ADDENDUM NUMBER 4

**LINCOLN COMPLEX – BUILDING O O.A.R., LIBRARY SERVICES AND I.T.
RENOVATIONS
930-B Oak Street SE, Albuquerque, NM 87106
ALBUQUERQUE PUBLIC SCHOOLS**

APS RFP No. 21-031-RRR

Date of Issue: 12/15/2020

LEVEL 1 LIGHTING
PLAN - SOUTH

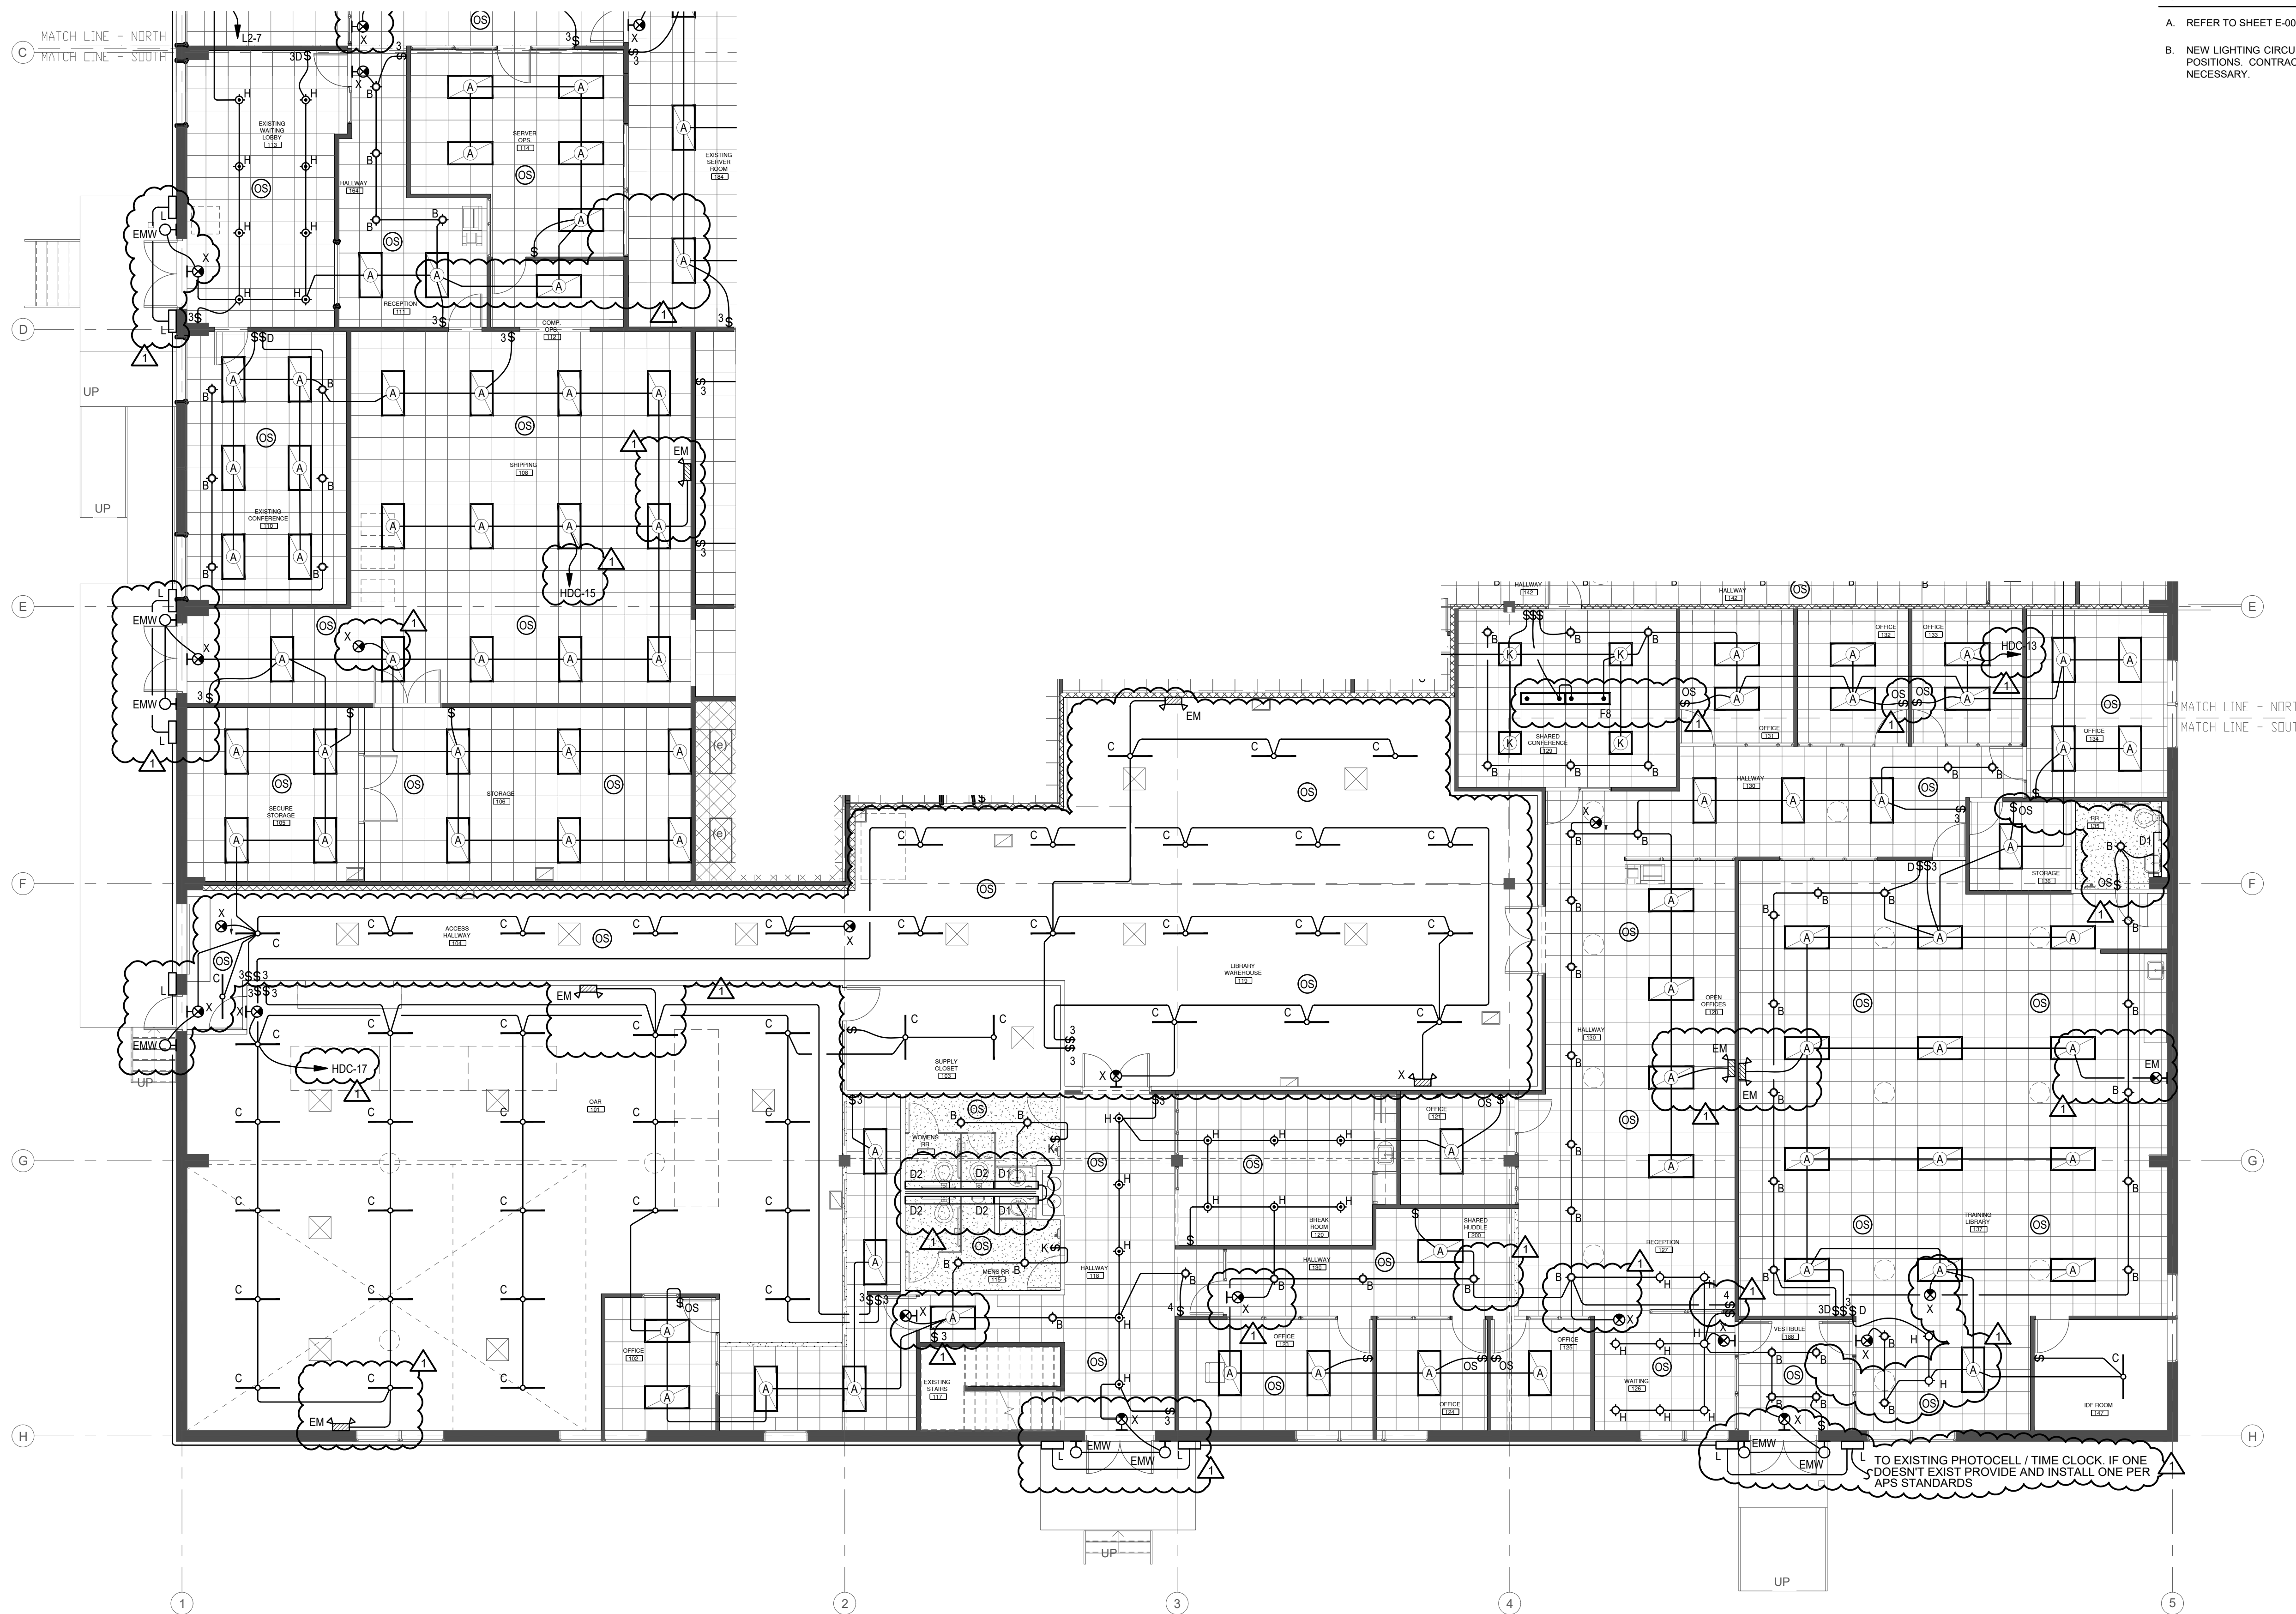
- 40) See attached Sheet E-101 for revised construction document drawing.
- 41) Sheet E-101 – Add General Note "Lighting controls shall be provided that comply with IBC 1006 for correct operation of lighting on loss of utility power and transfer to generator power."

LEVEL 1 LIGHTING PLAN - NORTH

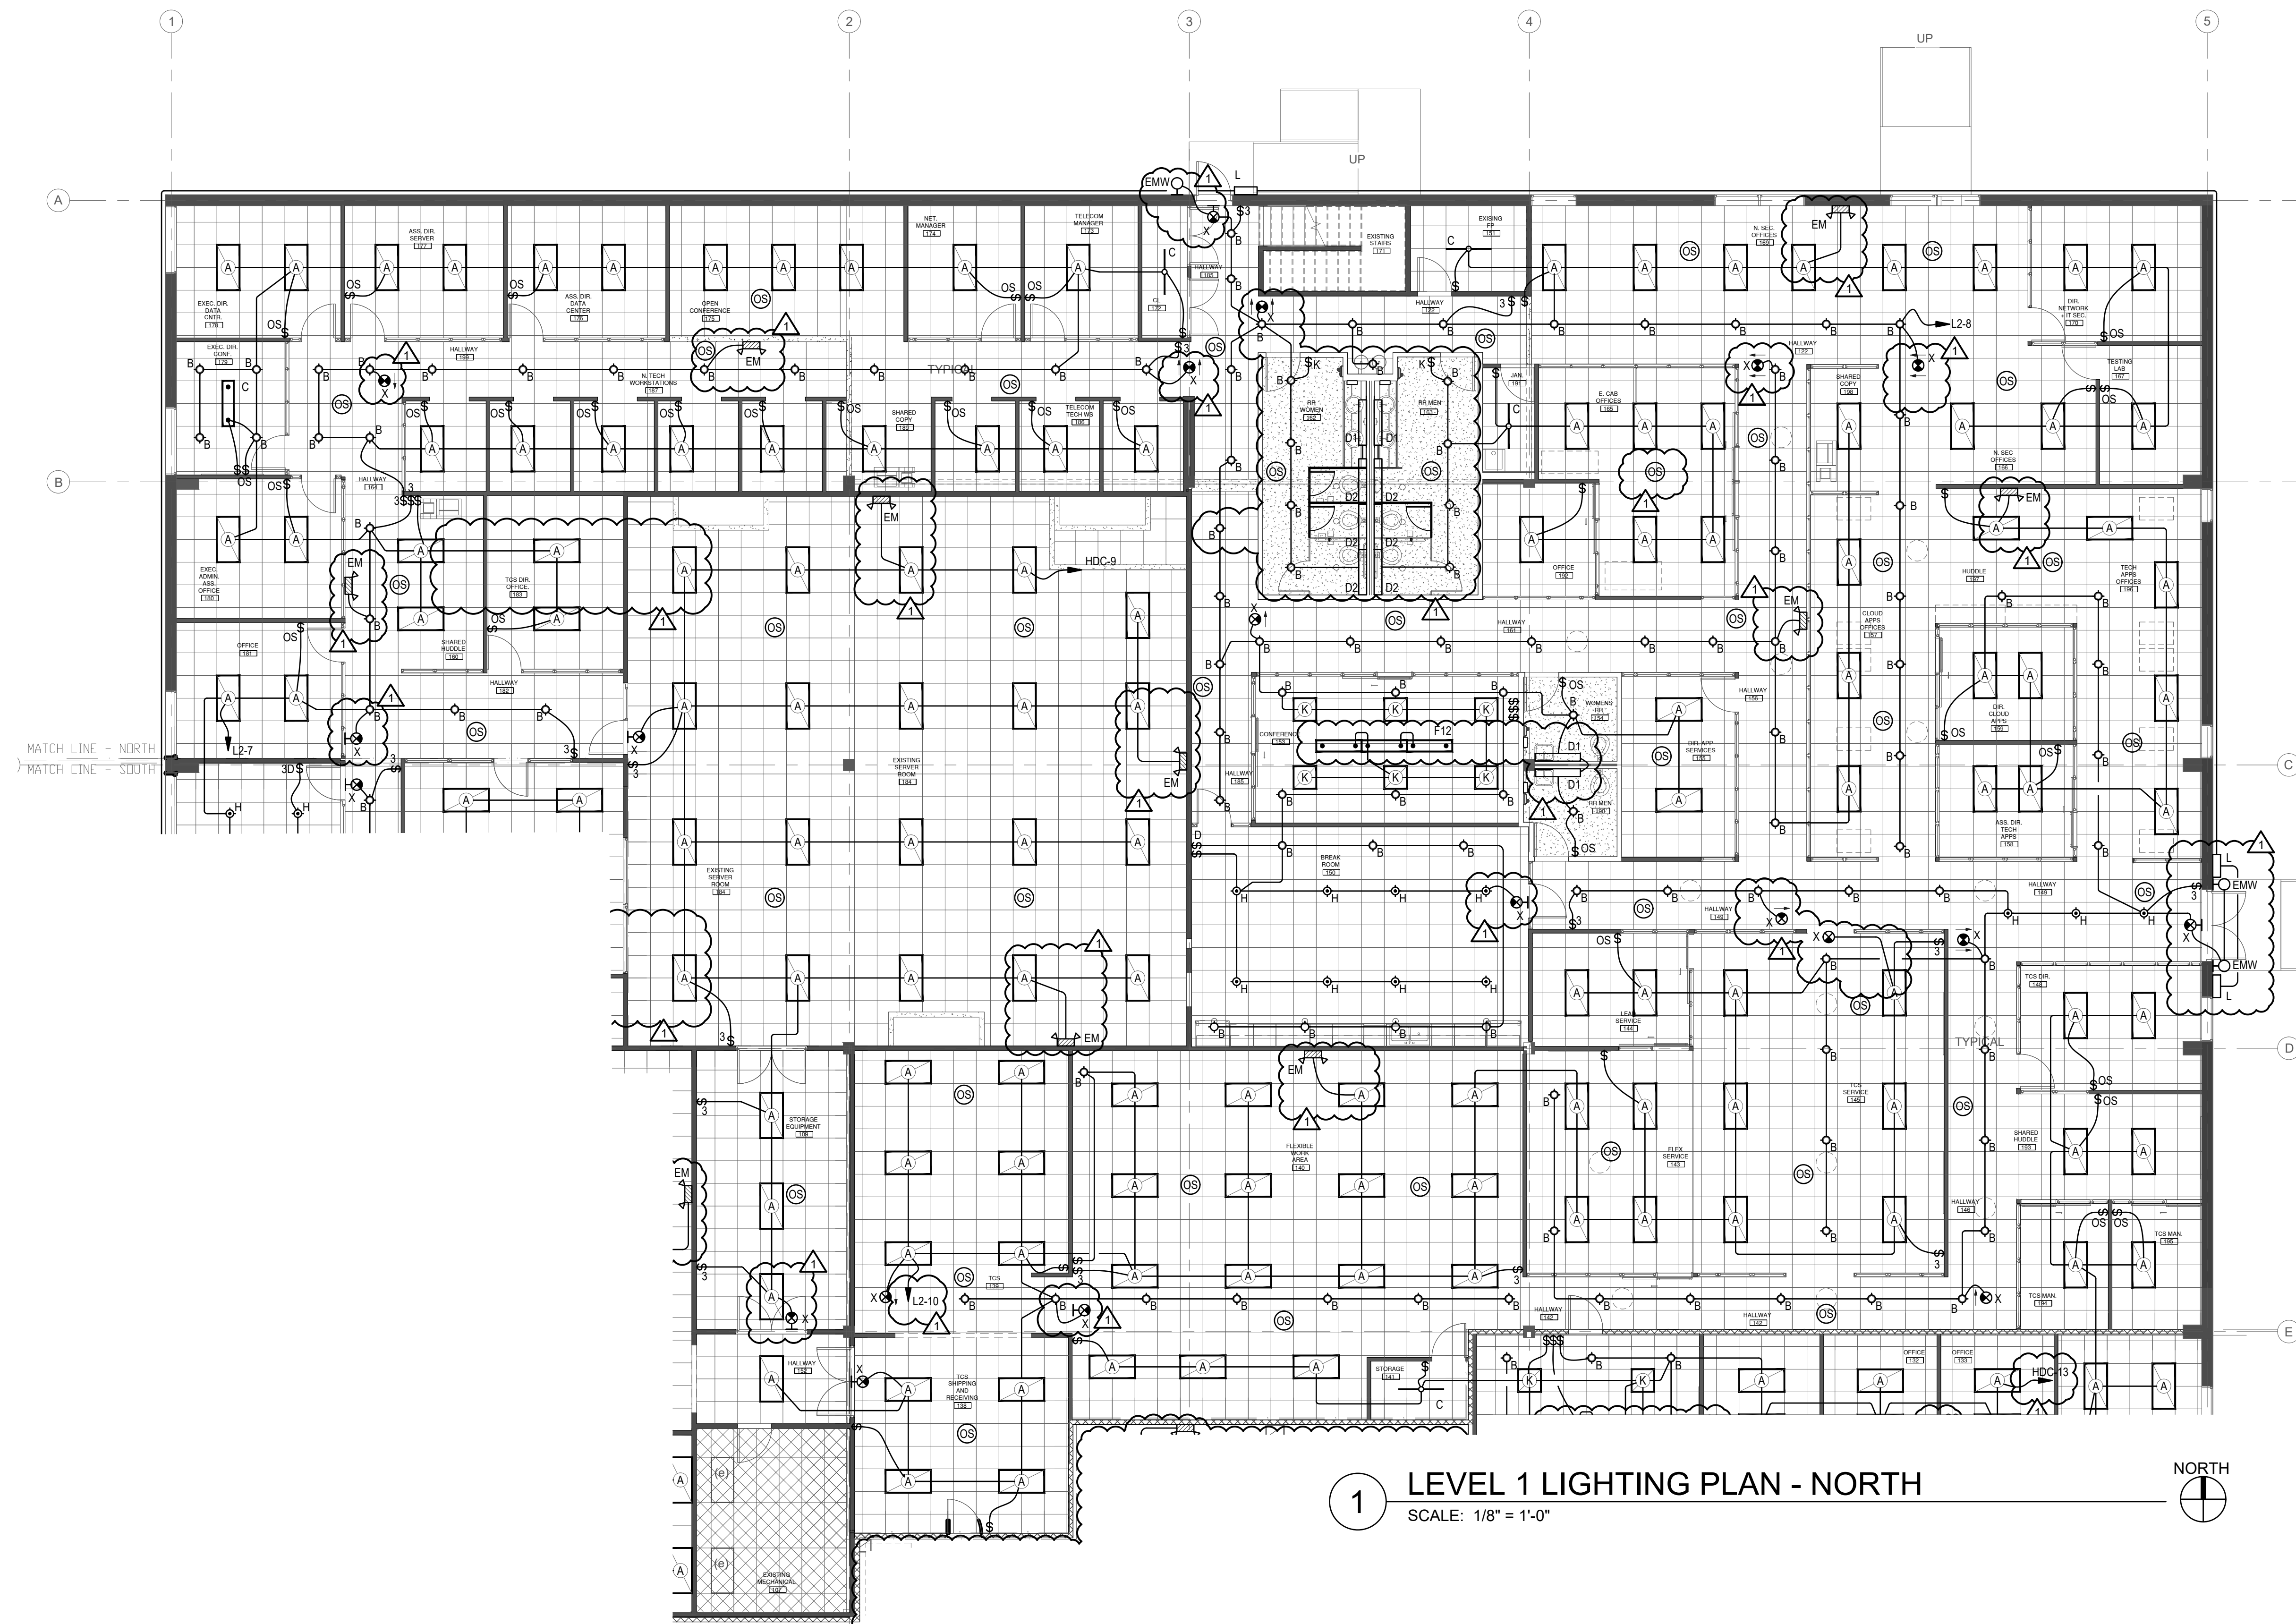
- 42) See attached Sheet E-102 for revised construction document drawing.
- 43) Sheet E-102 – Add General Note "Lighting controls shall be provided that comply with IBC 1006 for correct operation of lighting on loss of utility power and transfer to generator power."

DATE: 12-14-2020 SHEET: E-303
JOB #: 19040

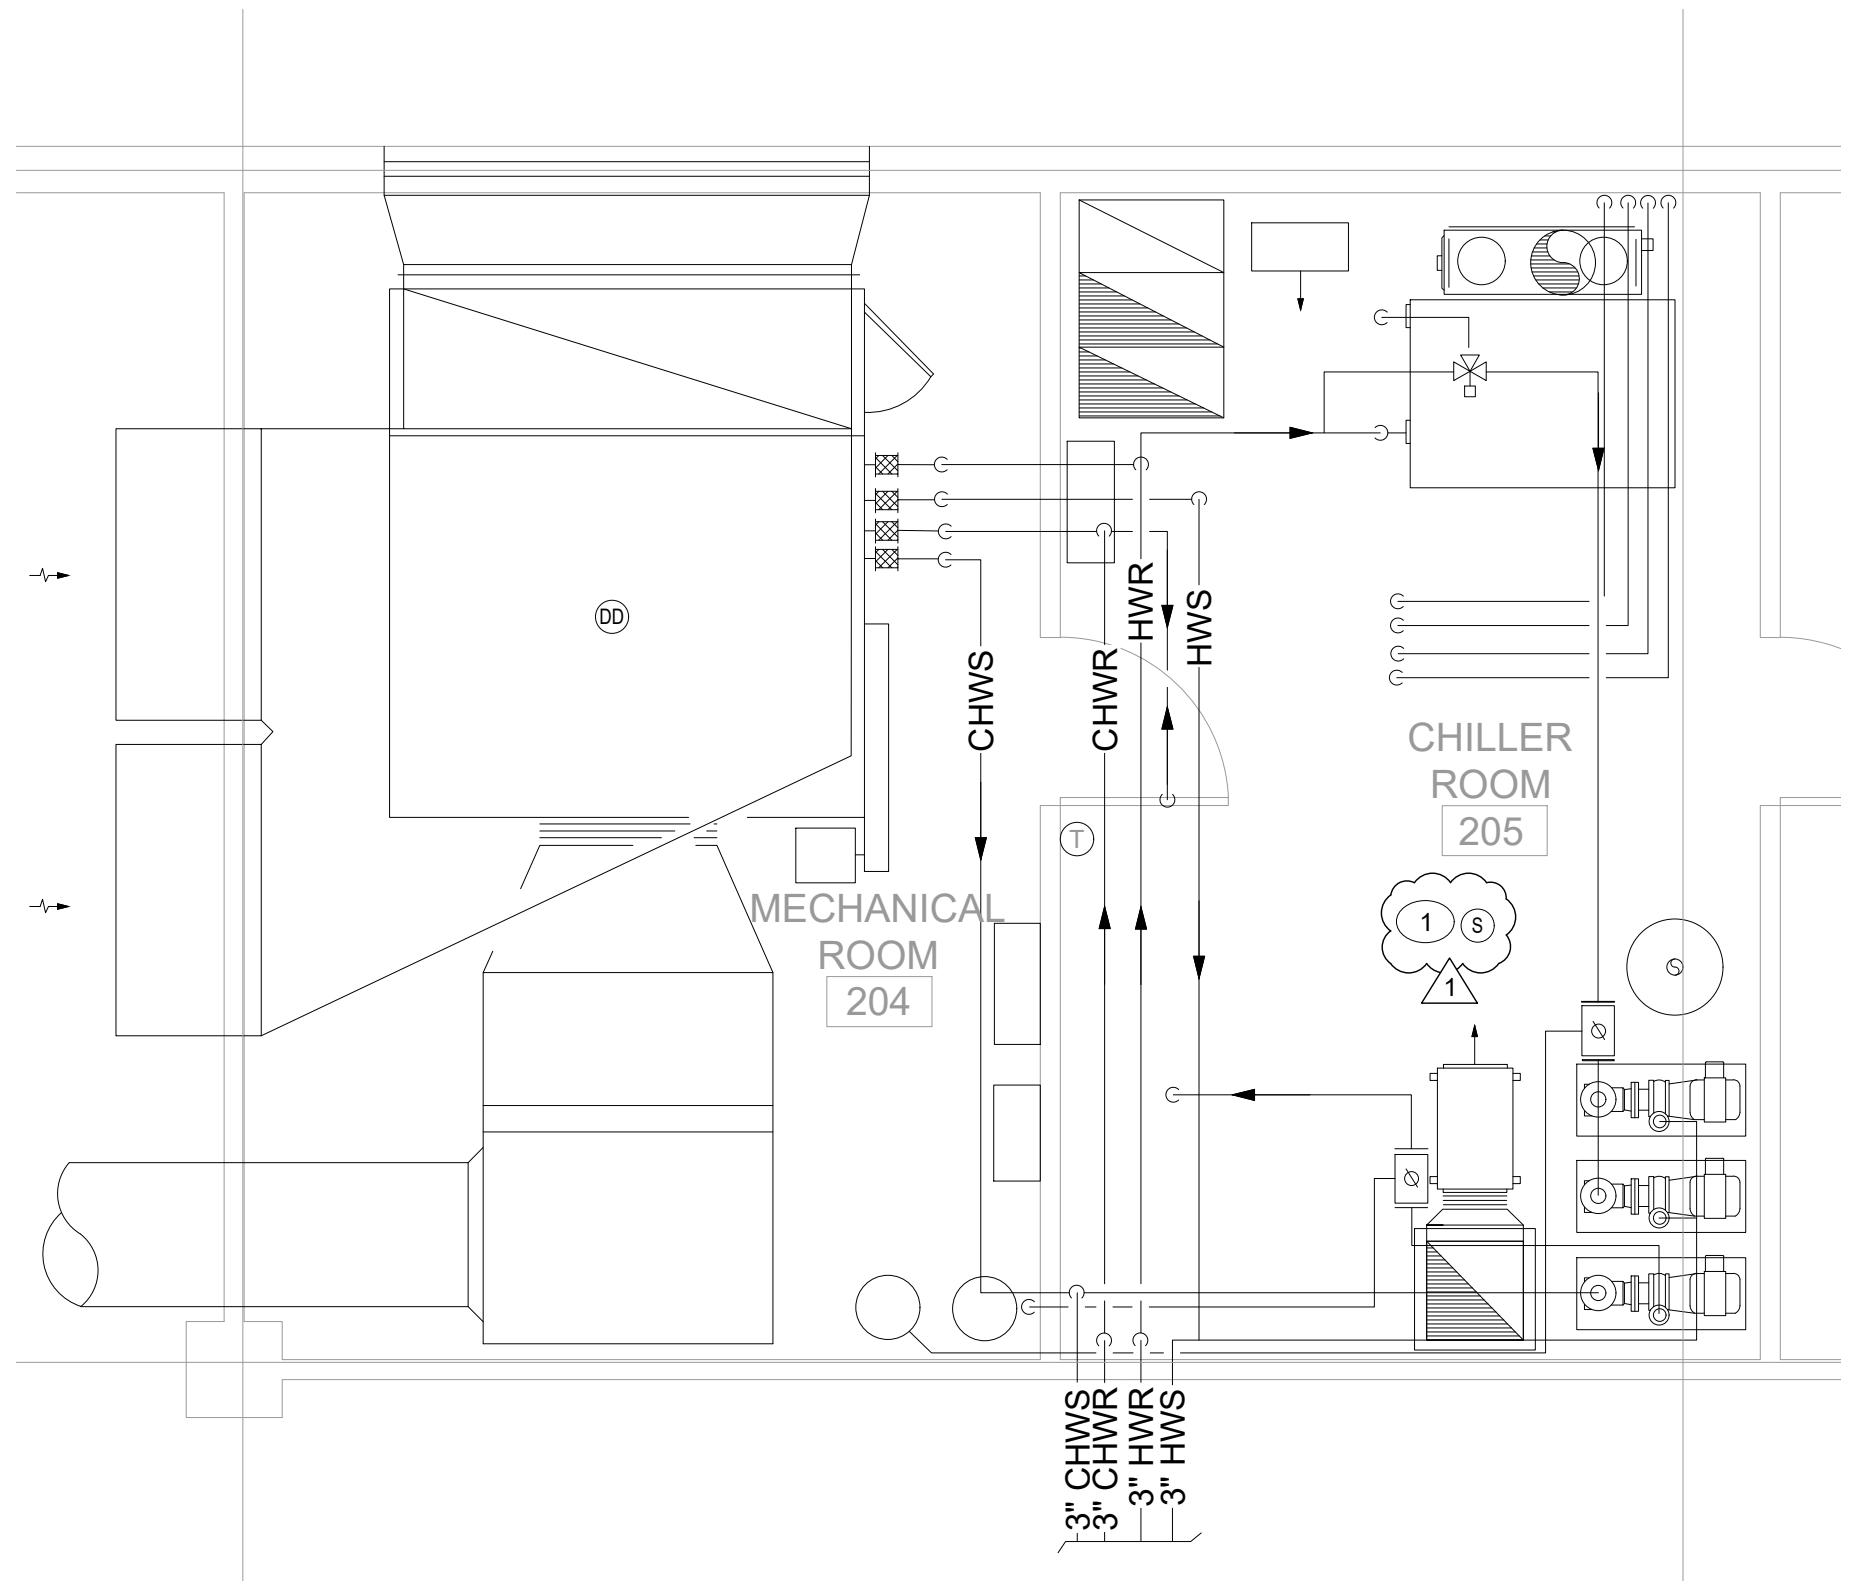
50) See attached sketch SK-E-303-01 for added smoke detectors.
